PROPOSED TECHNICAL SPECIFICATION CHANGE

SEQUOYAH NUCLEAR PLANT UNITS 1 AND 2

DOCKET NOS. 50-327 AND 50-328

(TVA-SQN-TS-89-33)

FIGURE 3.2.3 RCS Total Flowrate Versus R_1 and R_2 - Four Loops in Operation

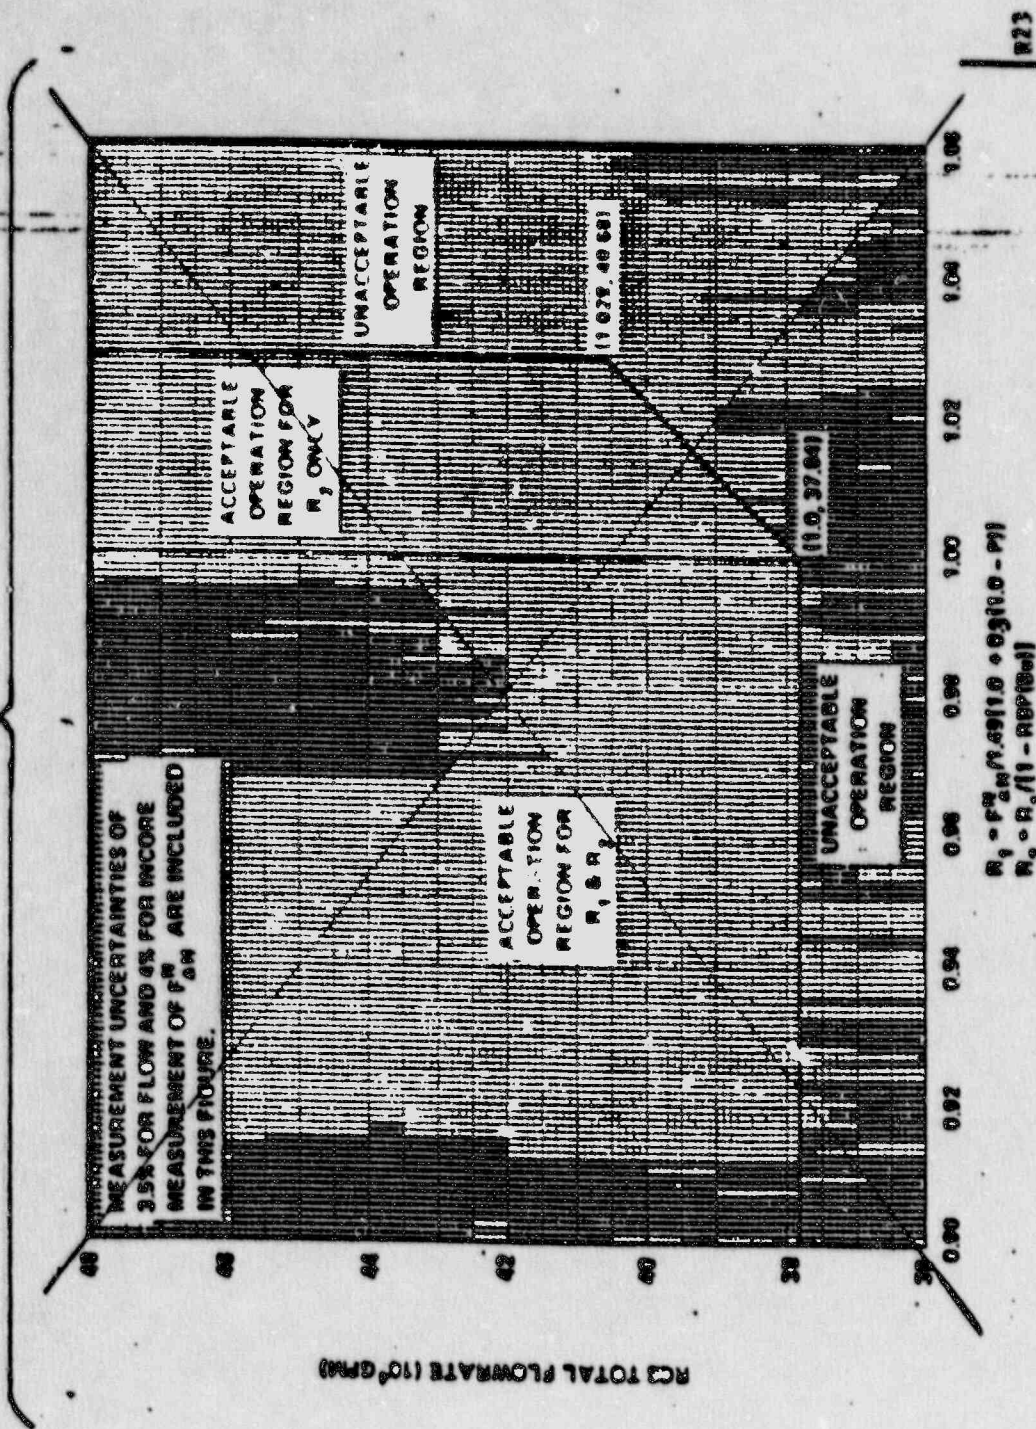
Delete

Delete

The requested change to SQN TS 3.2.3 will remove an unnecessary power peaking penalty and simplify the format of the specification. The current specification format includes RCS flow not only to maintain the minimum required RCS flow but also to provide for an additional offset against rod bow penalty. The use of RCS flow to compensate for rod bow penalty will no longer be required.

FIGURE 3.2-3 RCS Total Flowrate Versus R_1 and R_2 - Four Loops in Operation

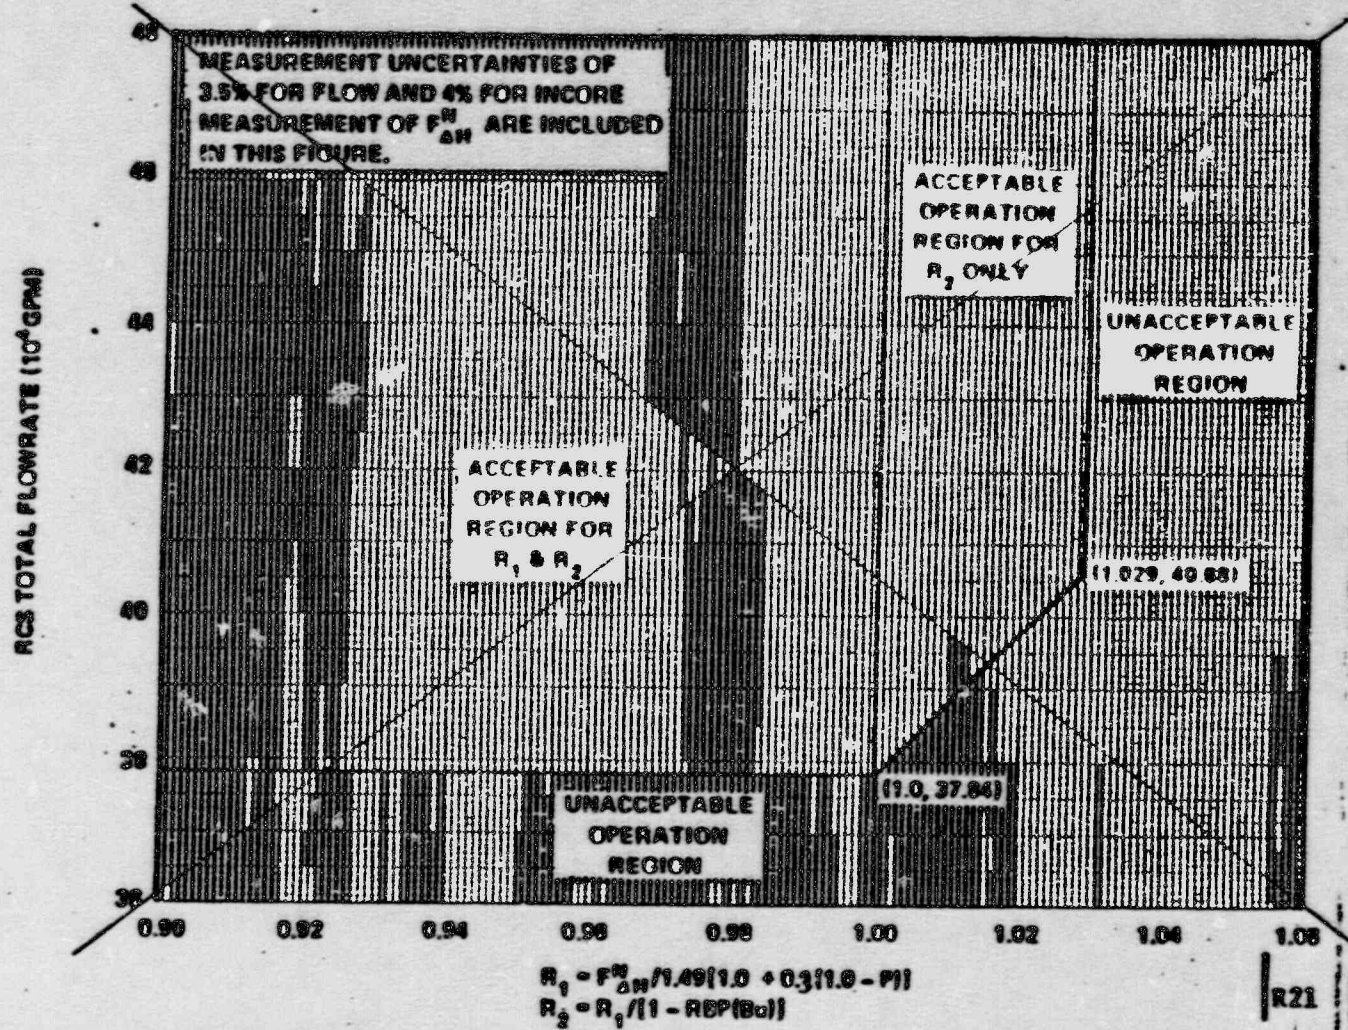
Delete

FIGURE 3.2.4 ROD BOW PENALTY VERSUS REGION AVERAGE BURNUP

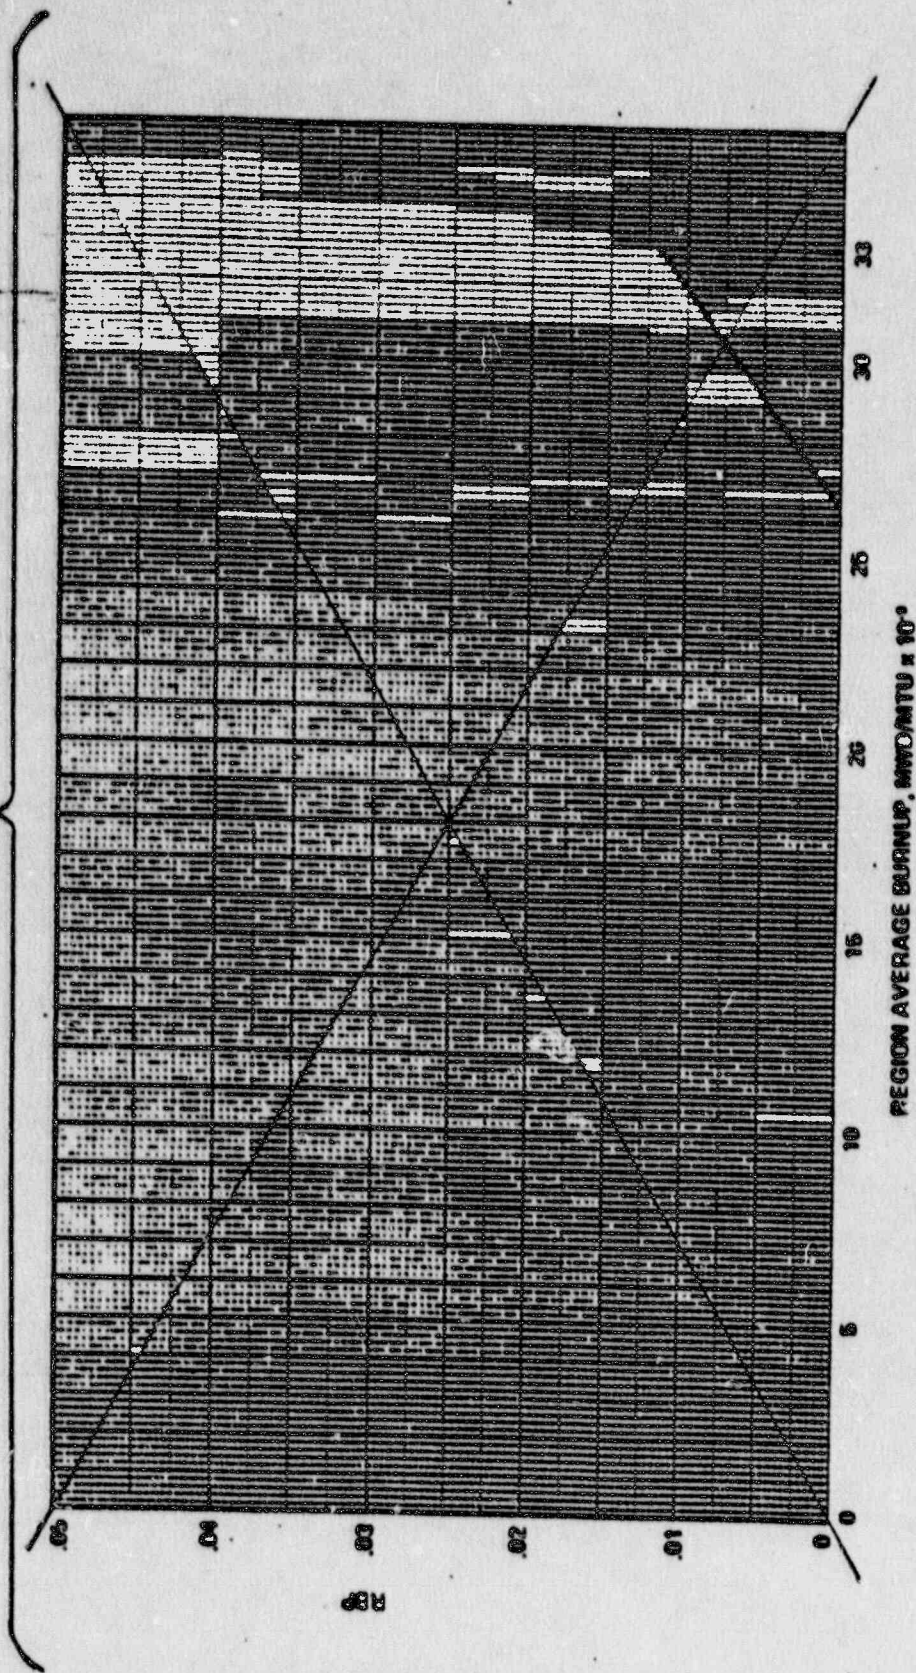
Delete

New statistical methods have been developed by Westinghouse that verify that the past treatment of rod bow penalty provided an overestimation of the effects on DNB. Application of the new methods to SQN for the standard and the V5H fuel products has verified the reduction in rod bow penalty. The reduction allows for accommodation of the entire penalty in the establishment of the safety limit DNBR.

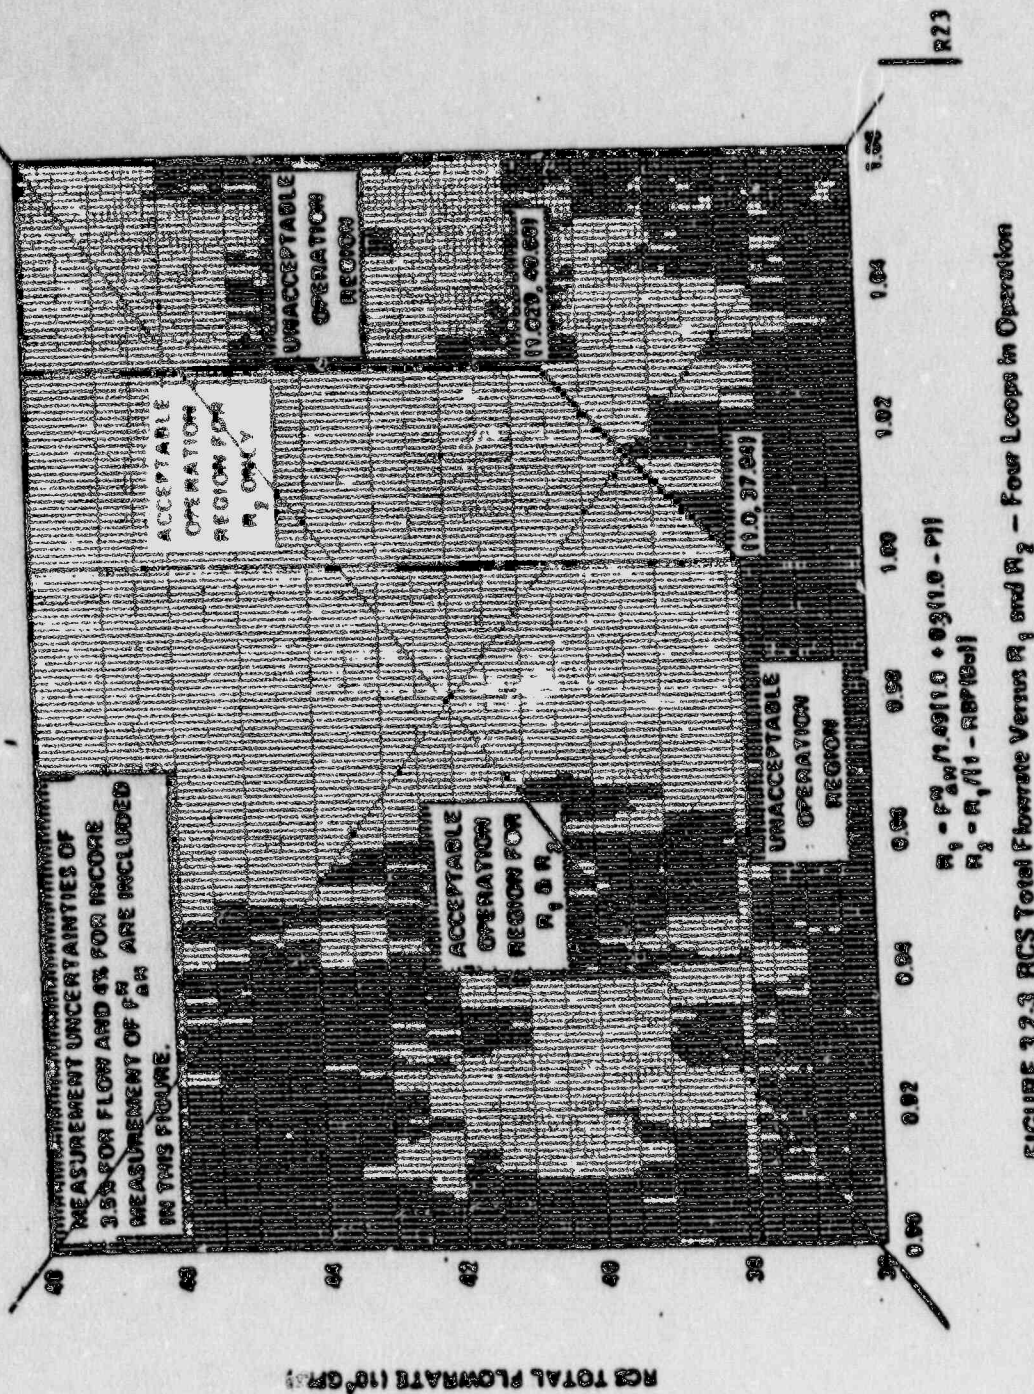
Delete

FIGURE 3.2.4 ROD BOW PENALTY VERSUS REGION AVERAGE BURNUP

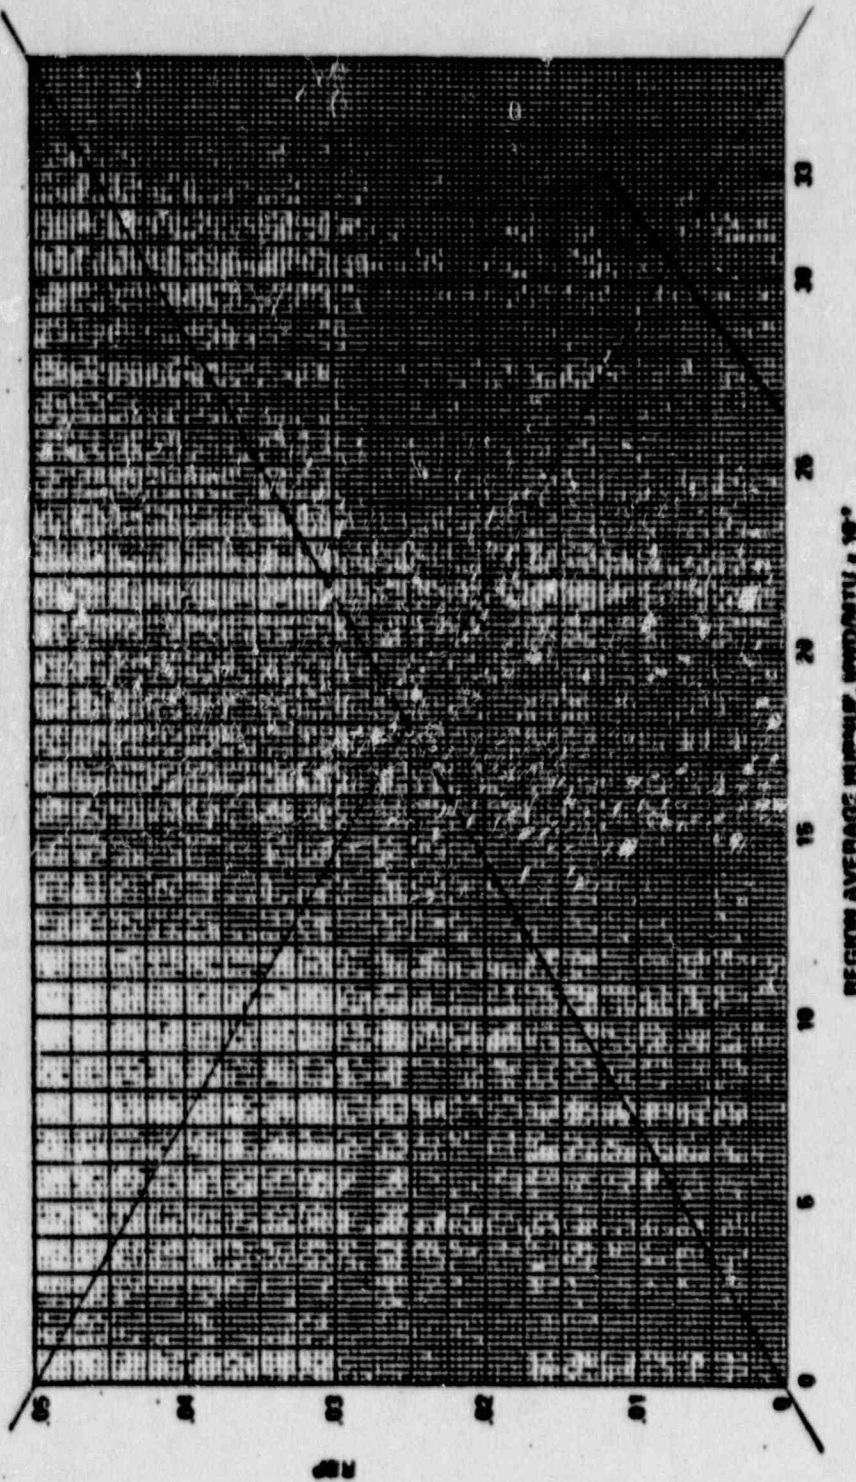
Delete

FIGURE 3.2.3 RCS Total Flowrate Versus R_1 and R_2 - Four Loops in Operation

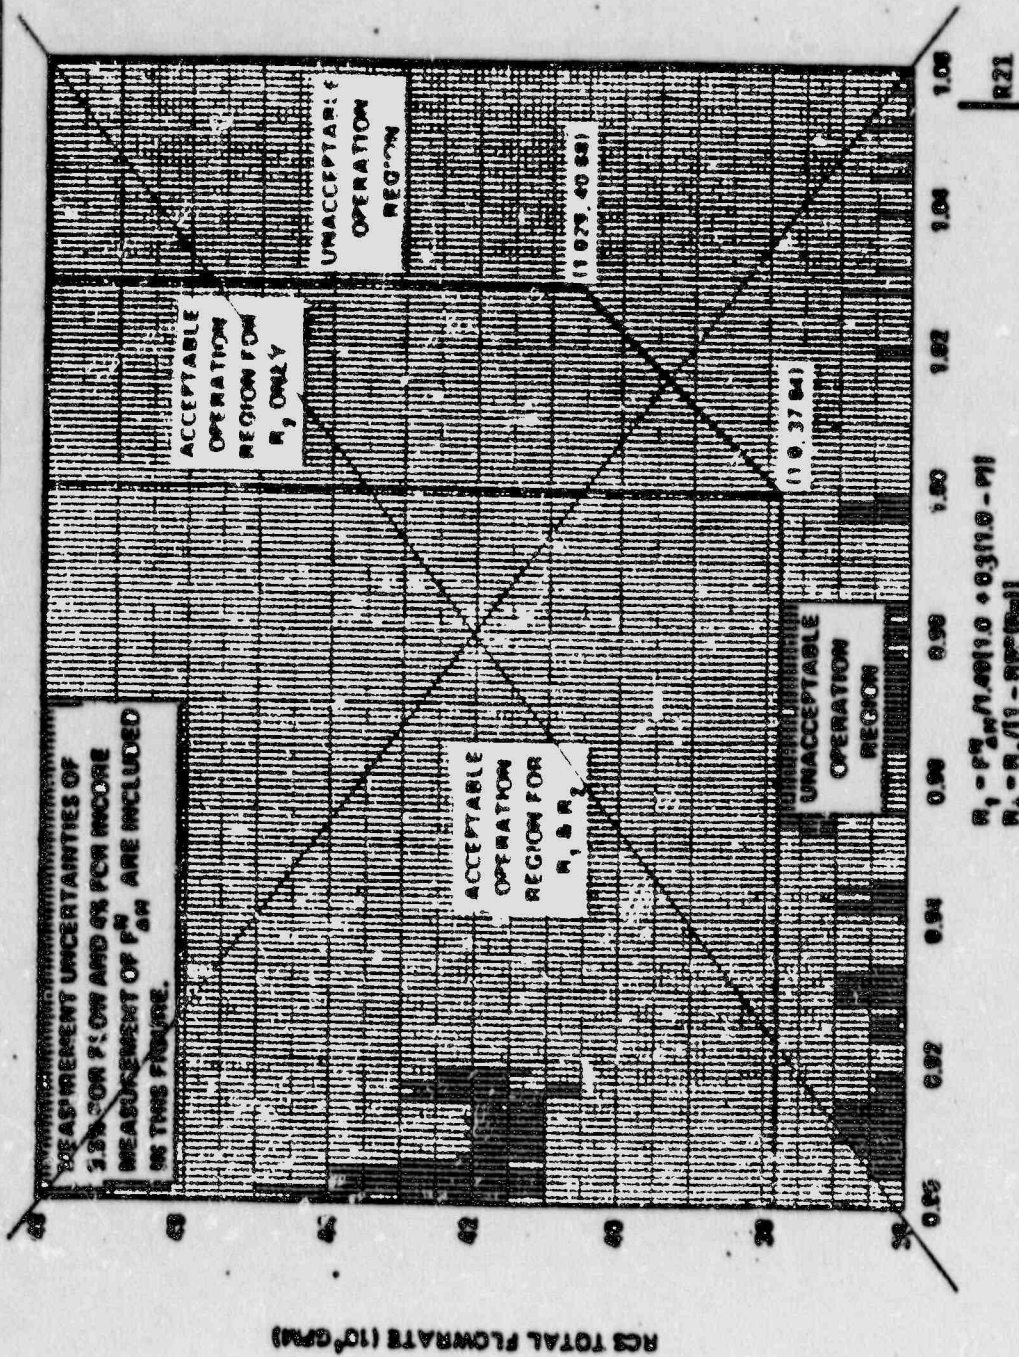
Delete

FIGURE 3.2.4 ROD BOW PENALTY VERSUS REGION AVERAGE BURNUP

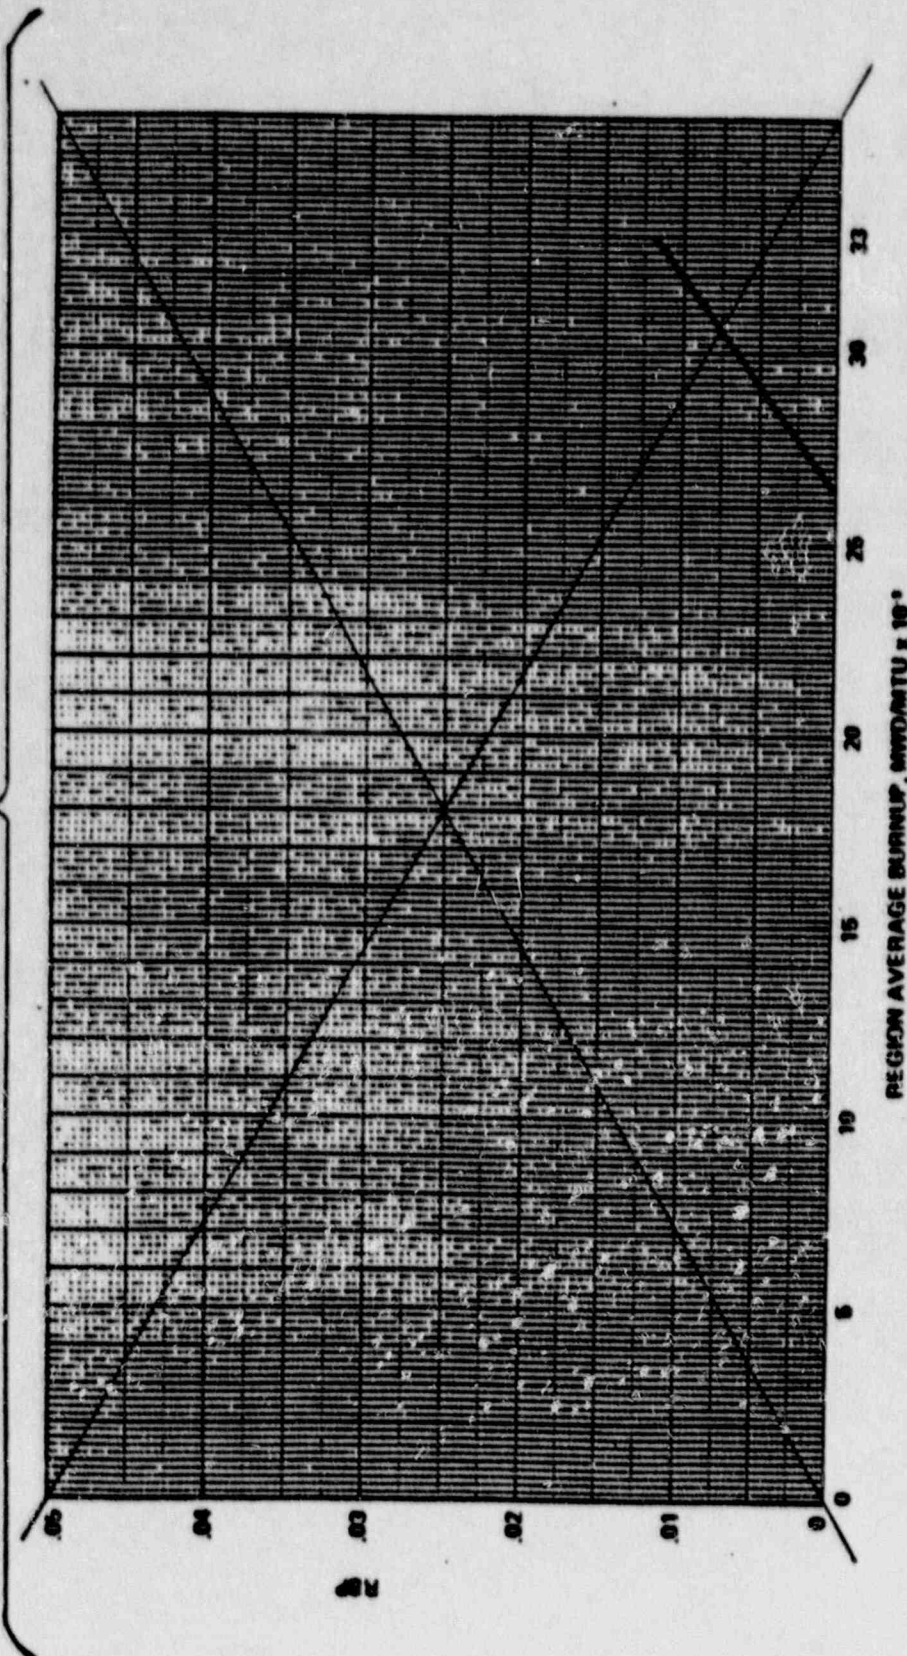
Delete
